STAFF REPORT

AGENDA ITEM: Planned Unit Development Concept Plan Review for Continental

The City has received a request from Continental 483 Fund LLC (c/o Gwyn Wheeler) for a review of a Planned Unit Development (PUD) Concept Plan. The proposal is for a 300 unit multi-family residential development on a 20.36-acre parcel to be called Springs Apartments.

Concept Site Plan Review

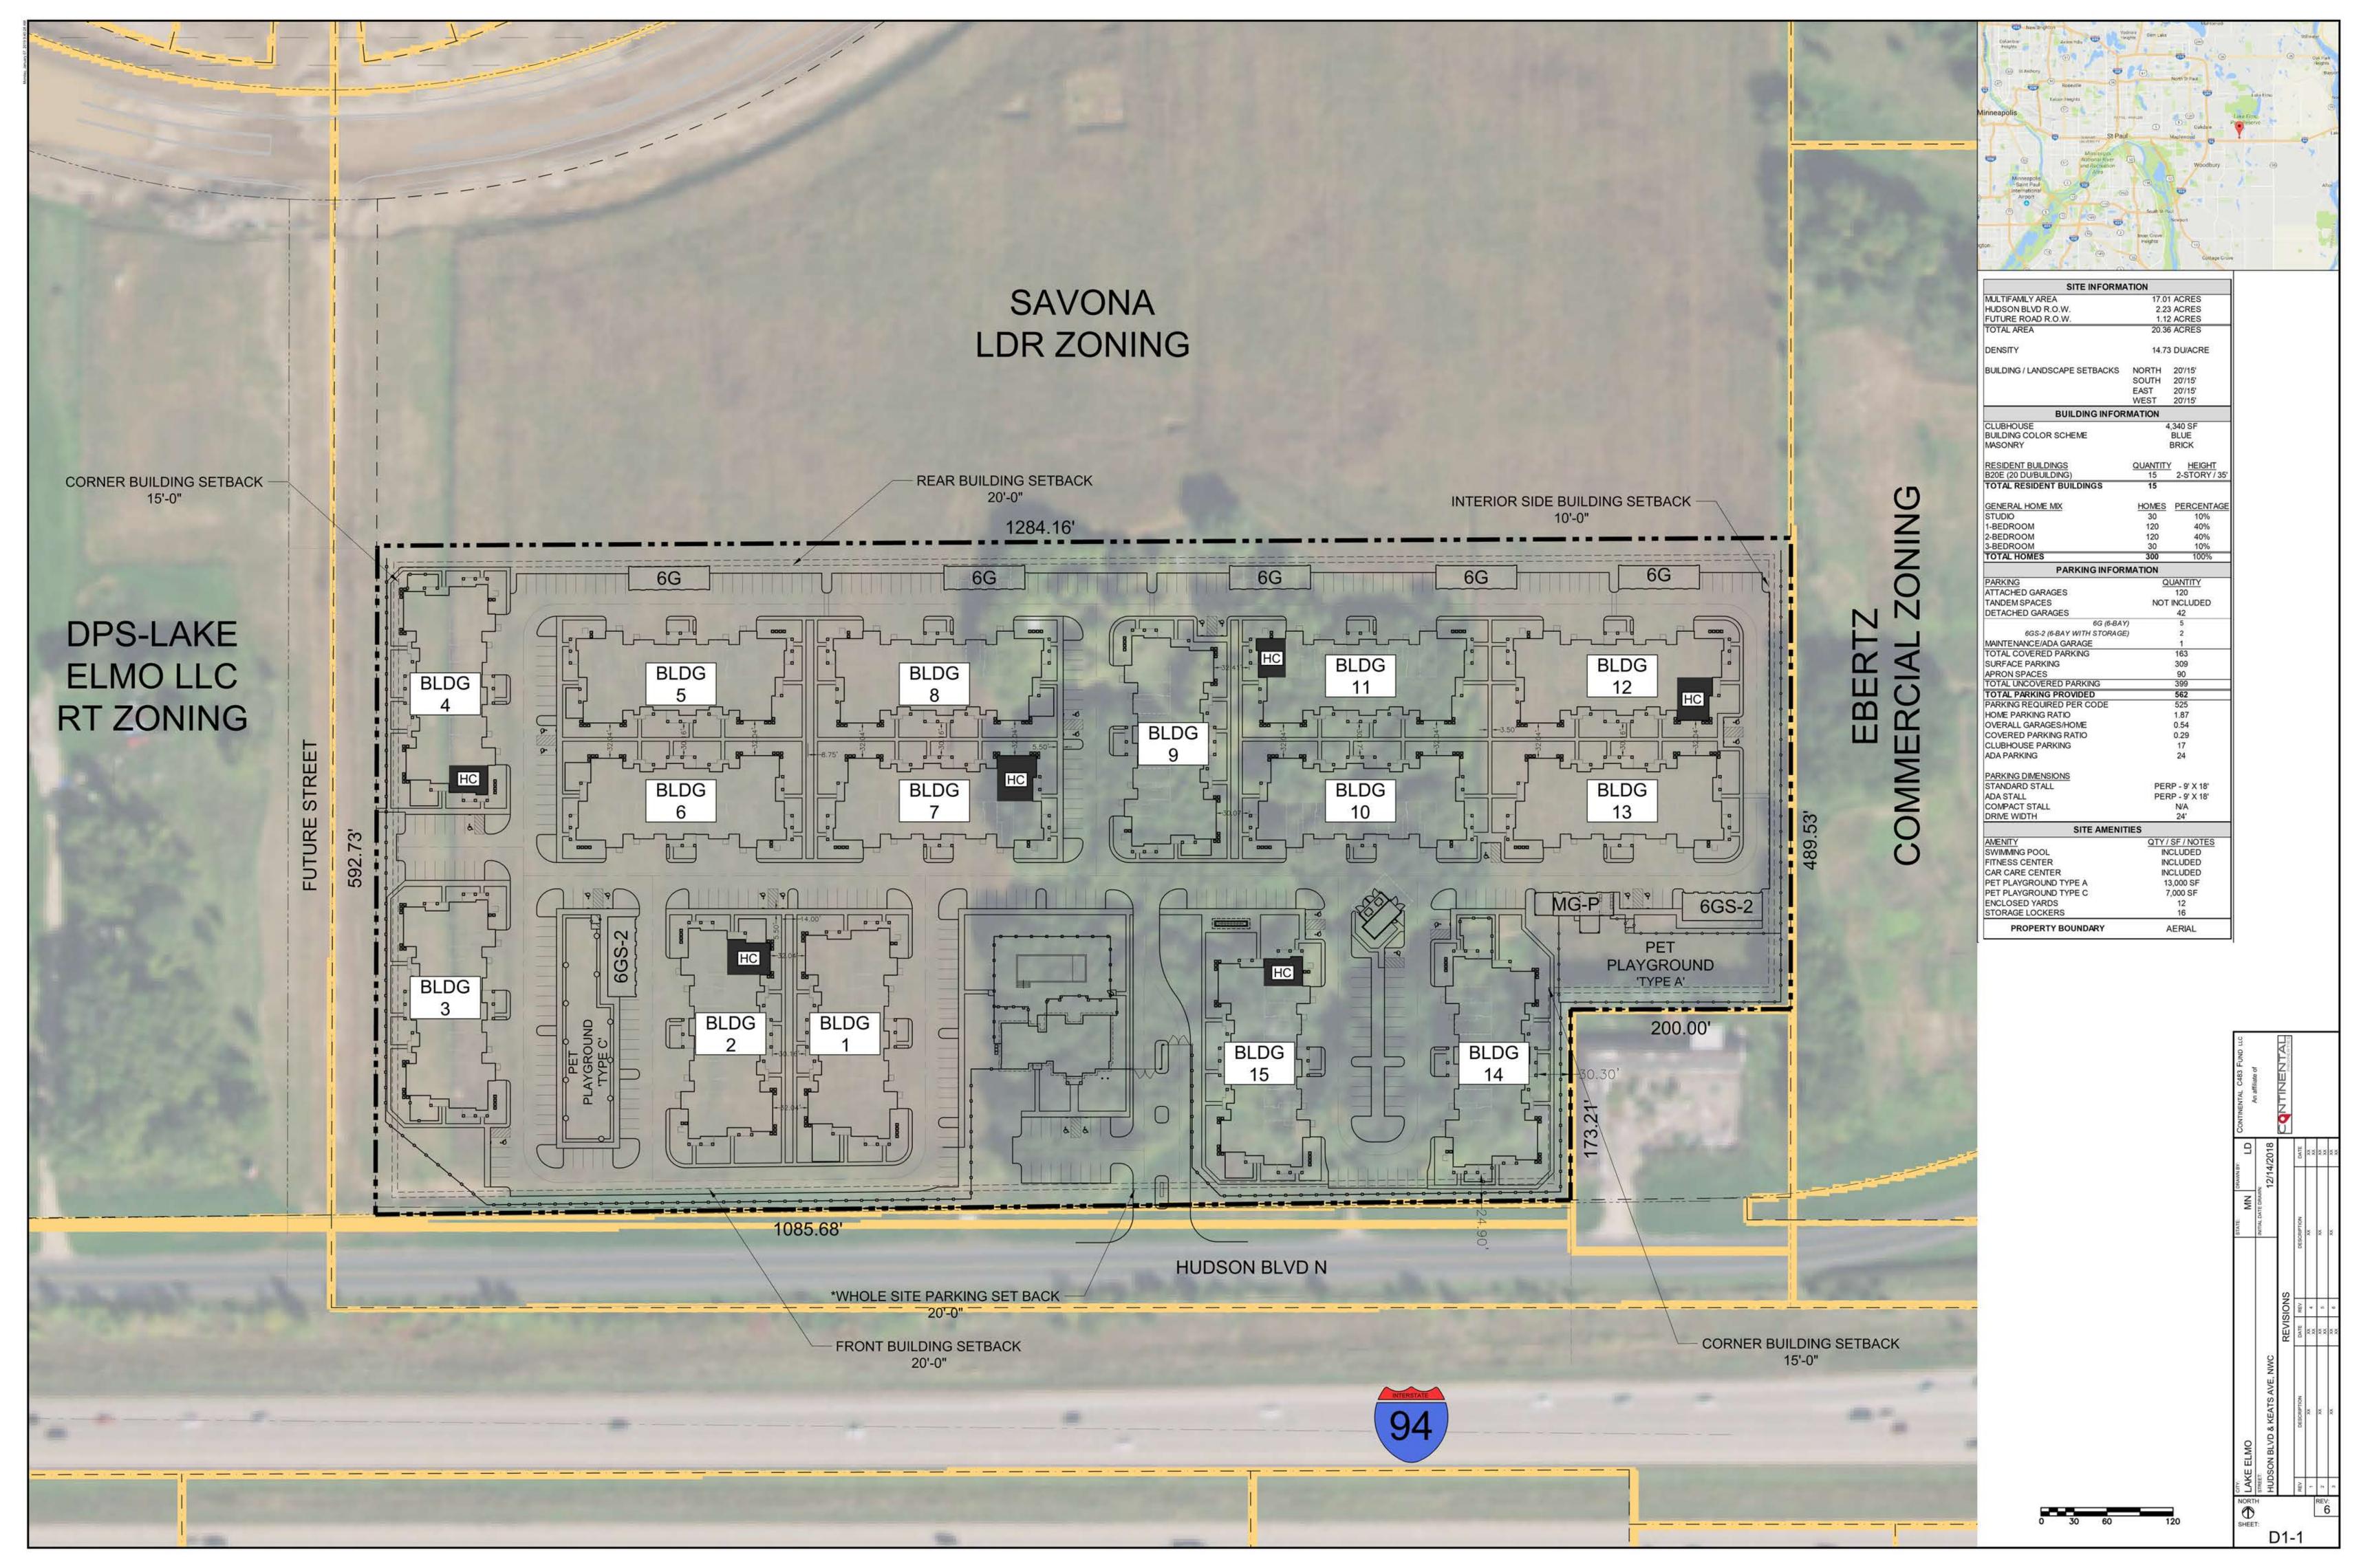
- Site Access. The concept plan proposes a single primary access to the site on Hudson Boulevard. The
 access is proposed approximately 770 feet east of the proposed new North-South Collector Road. Access
 spacing is adequate from the Collector Road (minimum required 660 feet) but is only 400 feet from the
 existing private driveway to the east adjacent parcel. Either the private driveway access should be
 eliminated or the primary access to the development should located further west (recommenced 660 feet
 from collector road) to accommodate appropriate turn lane lengths to the site.

- Secondary/Emergency Access. The concept plan shows a secondary access to the new North-South Collector Street and is called out as proposed emergency access point. The emergency access will need to include a paved connection to the collector street. Further review for the need/design of this access will be needed during the preliminary planning.

- Perimeter Fence. A perimeter decorative fence is shown around most of the proposed site. The fence locations should be revised, where necessary, to preserve the City standard 10-foot utility easement.

- Private Streets. The streets interior to the development are proposed to remain privately owned and maintained. Interior street design may require revisions to provide adequate fire lanes and safety access.
